**HORIZONTAL DIRECTIONAL DRILL ANALYSIS
SPINNER ROAD CROSSING
PADEP SECTION 105 PERMIT NO.: E11-352
PA-CA-0069.0000-RD
(SPLP HDD No. S2-0080)**

**SPINNER ROAD CROSSING
PADEP SECTION 105 PERMIT NO.: E11-352
PA-CA-0069.0000-RD
(SPLP HDD No. S2-0080)**

This reanalysis of the horizontal directional drill (HDD) installation of a 20-inch and 16-inch diameter pipeline crossing under Wetland N17, Streams S-N17, Spinner Road, S-N34, and Wetland N18 (east to west), is in accordance with Stipulated Order issued under Environmental Hearing Board Docket No. 2017-009-L for HDDs listed on Exhibit 2 of the Stipulated Order. This HDD is number 8 on the list of HDDs included on Exhibit 2. This HDD was not initiated before the issuance of the Order.

Figure 1. Original 20-Inch HDD Plan and Profile

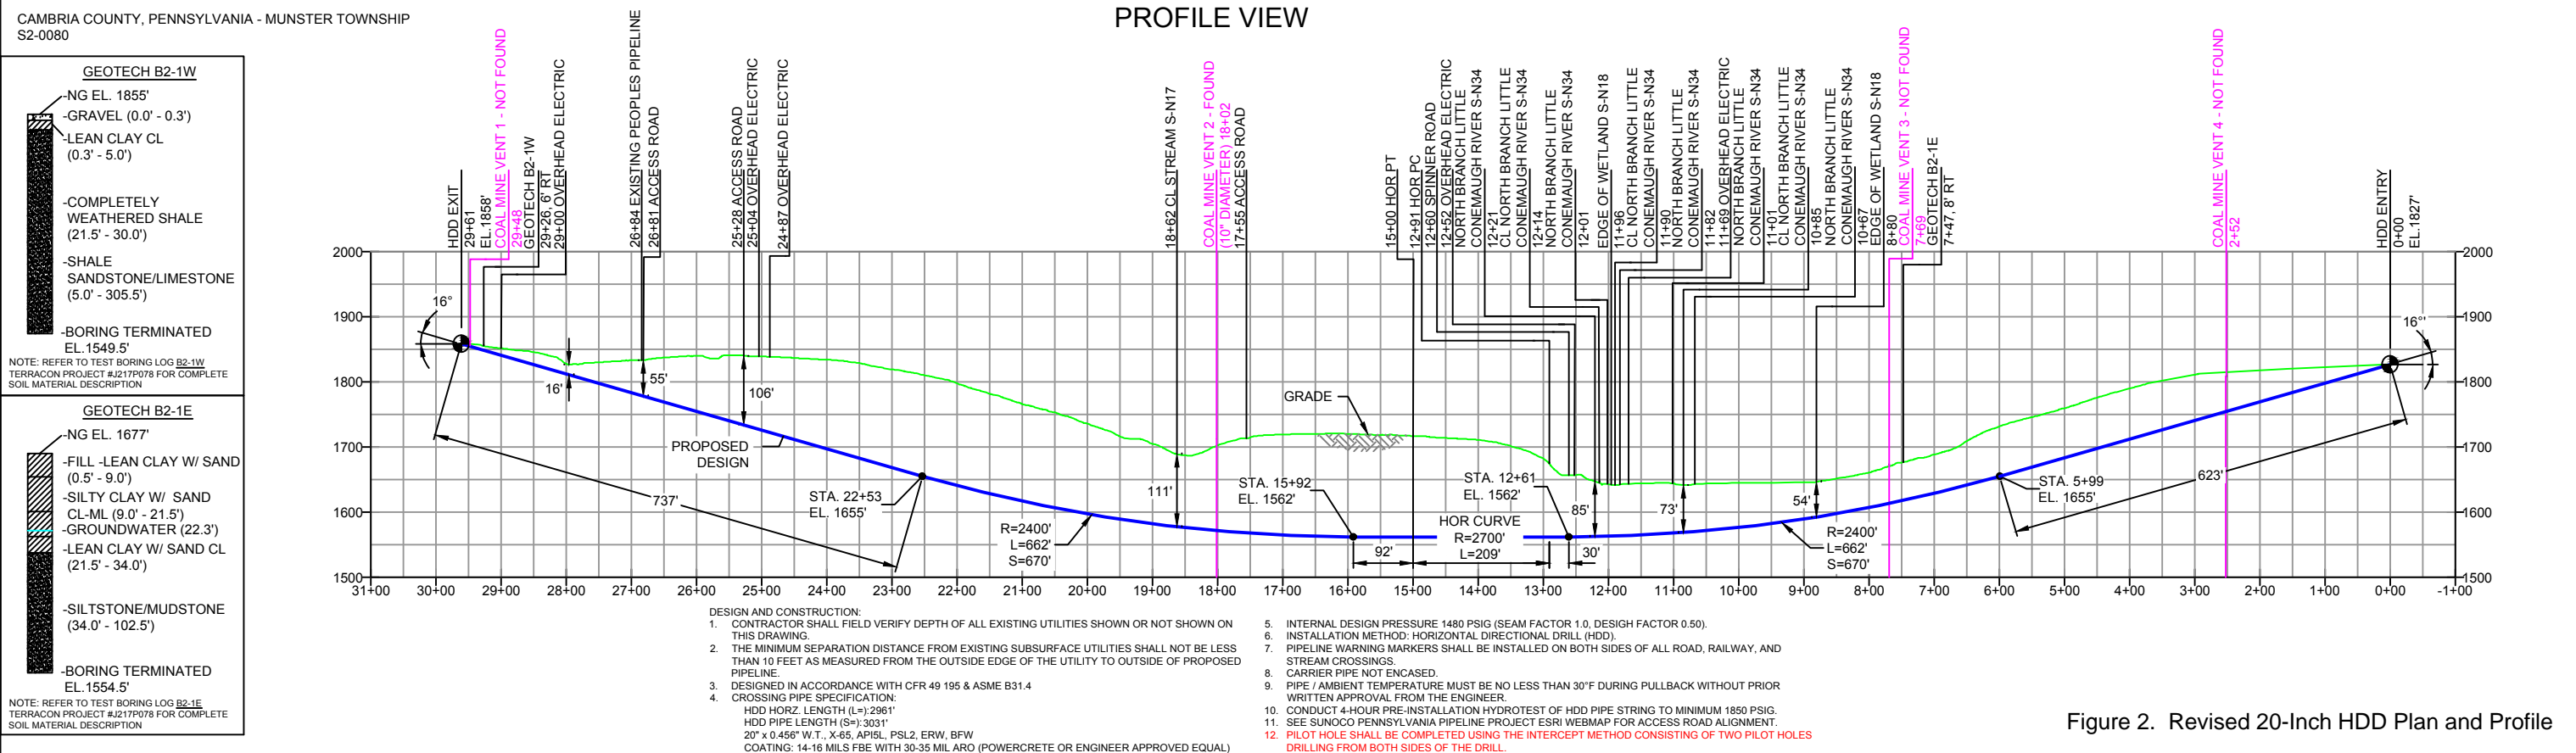
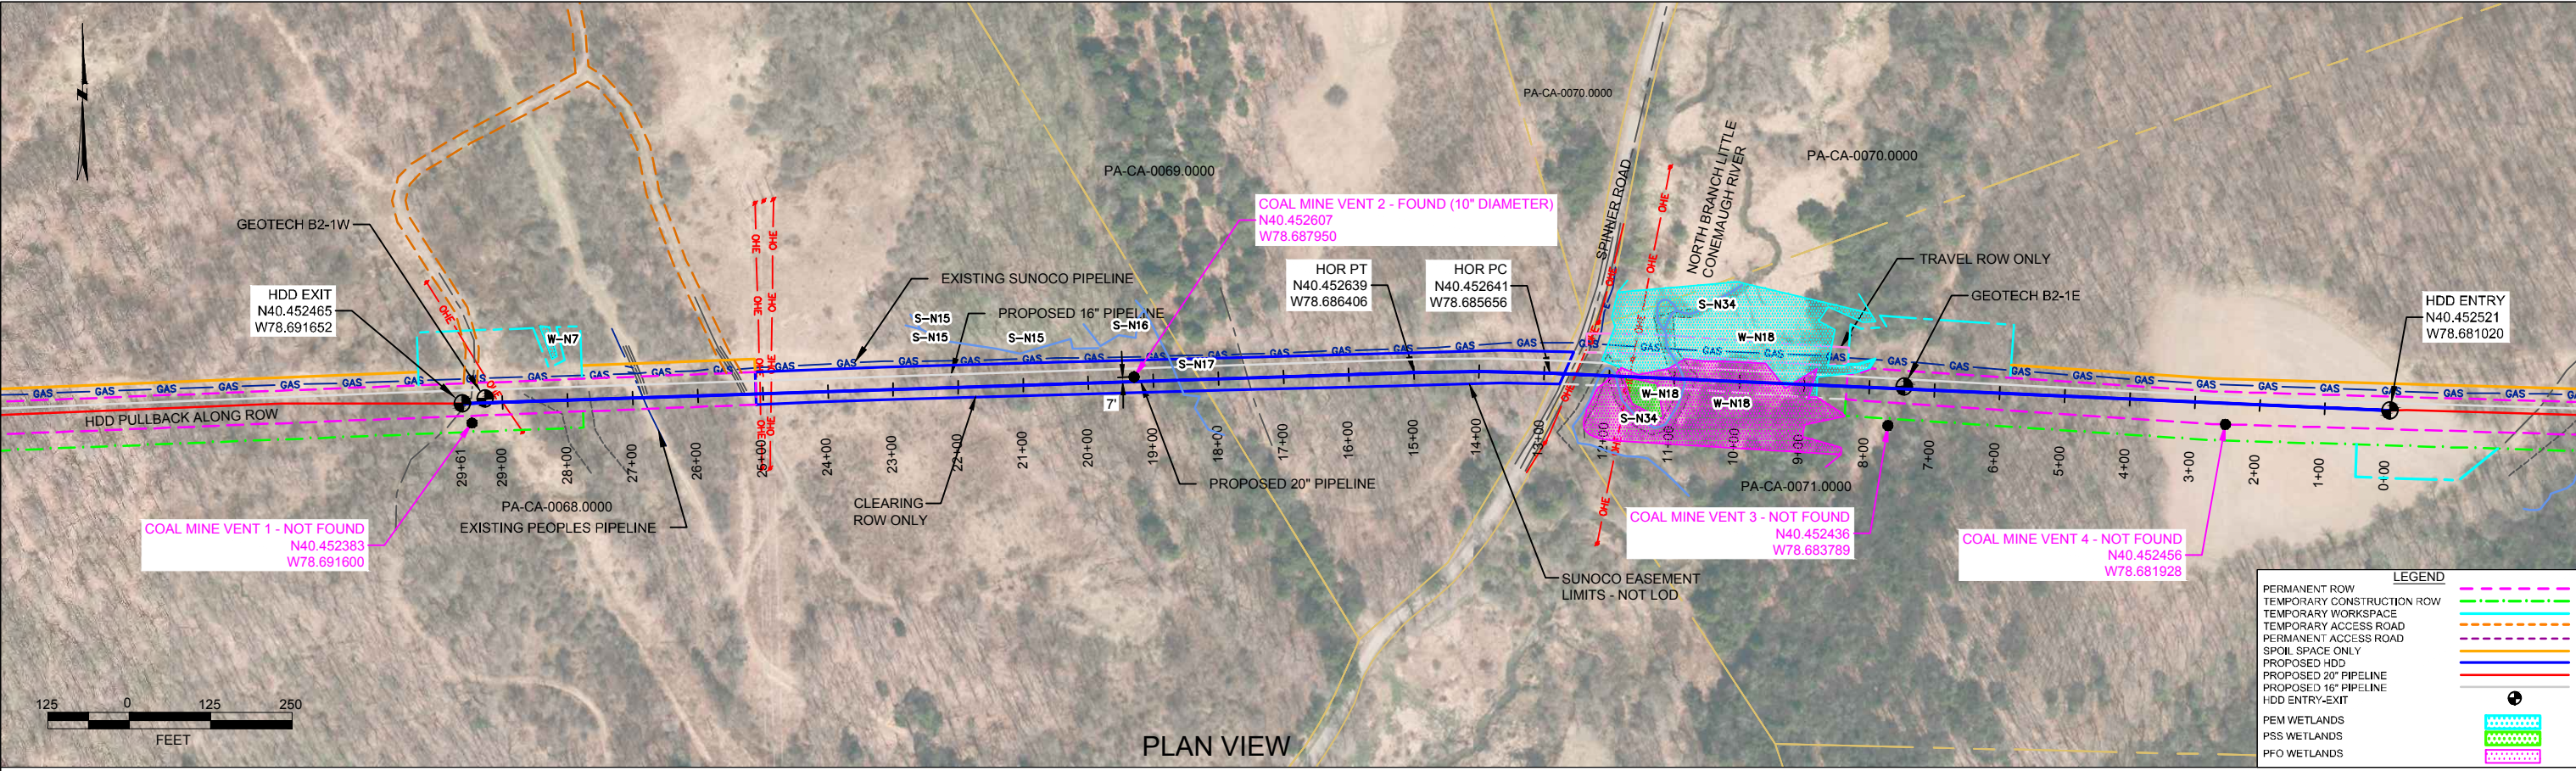
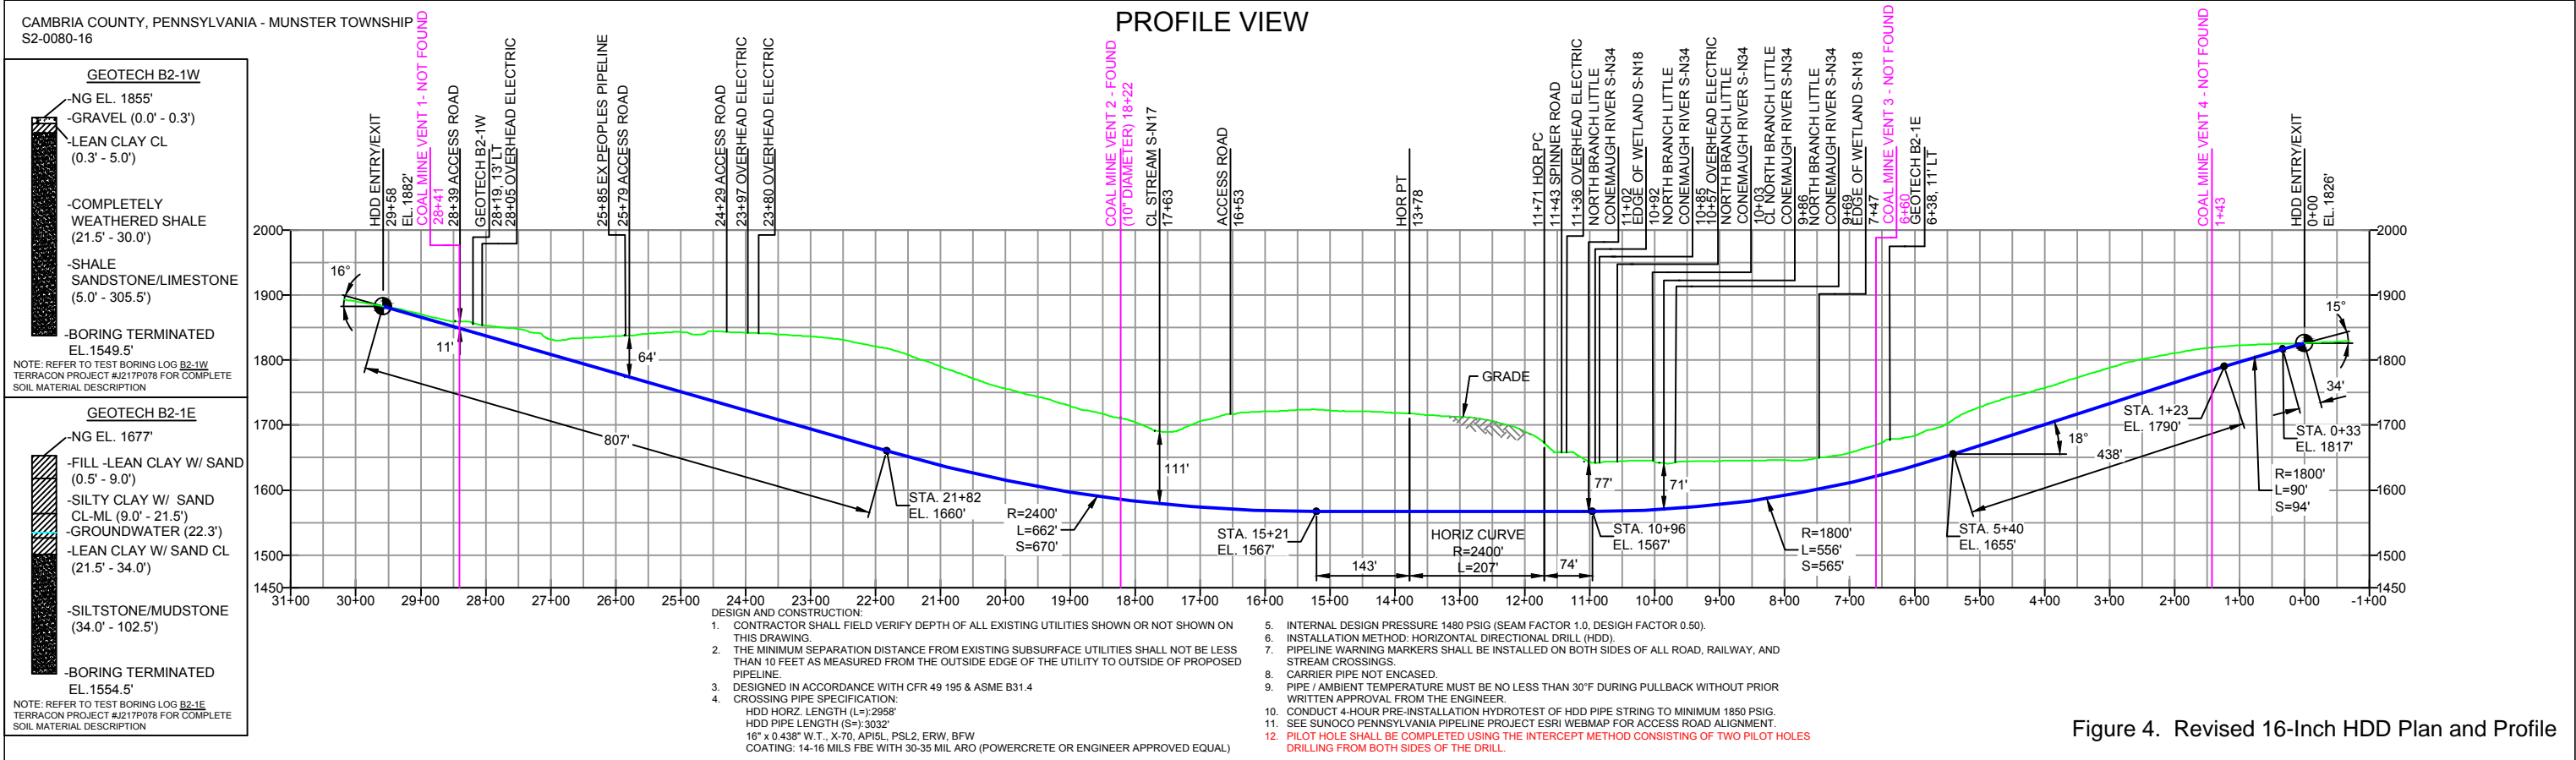
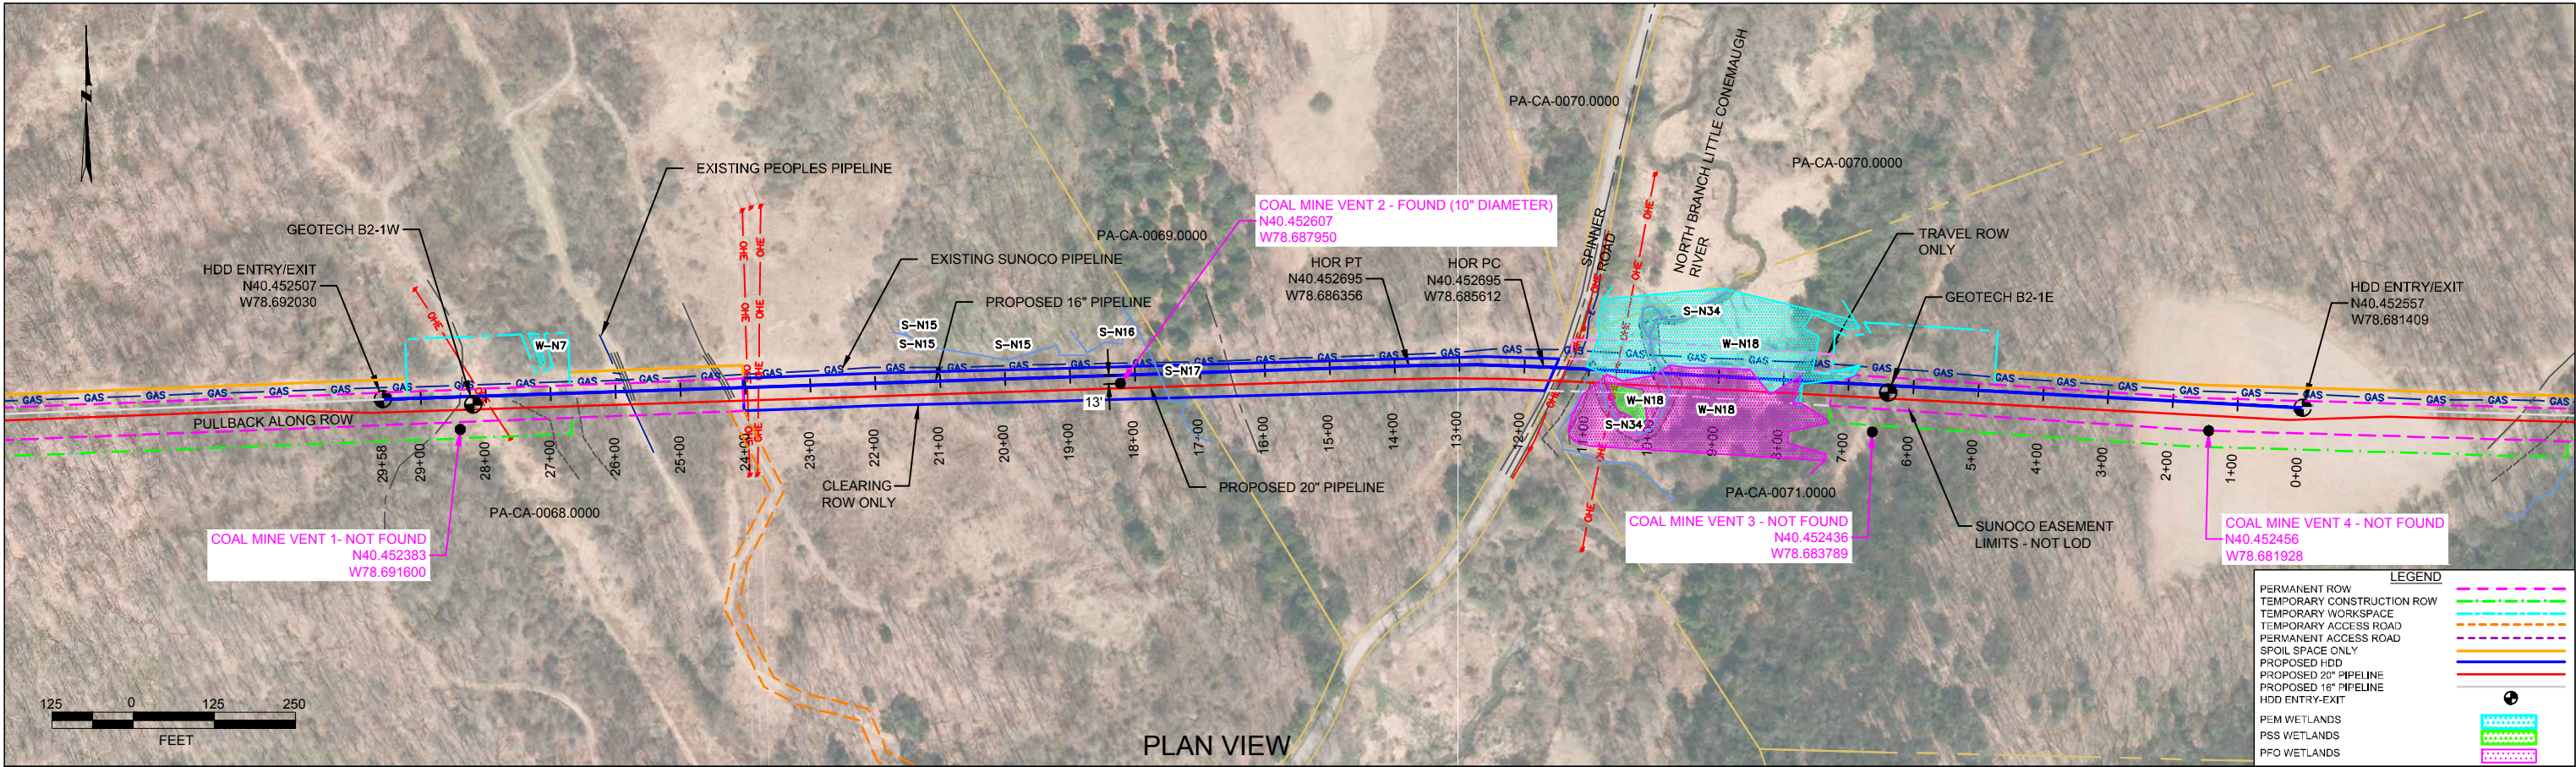
SPLP HDD consultants reviewed the HDD designs and geotechnical data for this location. Based upon this review, it was determined that the risk of IRs to regulated resources overlying the HDD could be reduced by increasing the depth of the original permitted HDD profile. Additional geologic investigations have been completed and utilized in the redesign of the planned HDD. The redesign adjusts the HDD profile deeper to place the HDD pathway through bedrock having better structural integrity than a shallower profile and increase the overall length of the HDD due to pipe design requirements. A summary of the redesign factors is provided below.

It is SPLP's intent to modify the original profile design and to pursue a deeper and longer HDD profile. Figure 1 and 3 in Attachment 4 presents the original HDD plan and profiles. Figure 2 and 4 present the revised HDD plan and profiles.

Revised Horizontal Directional Drill Design Summary: 20-inch

Revised Horizontal Directional Drill Design Summary: 16-inch
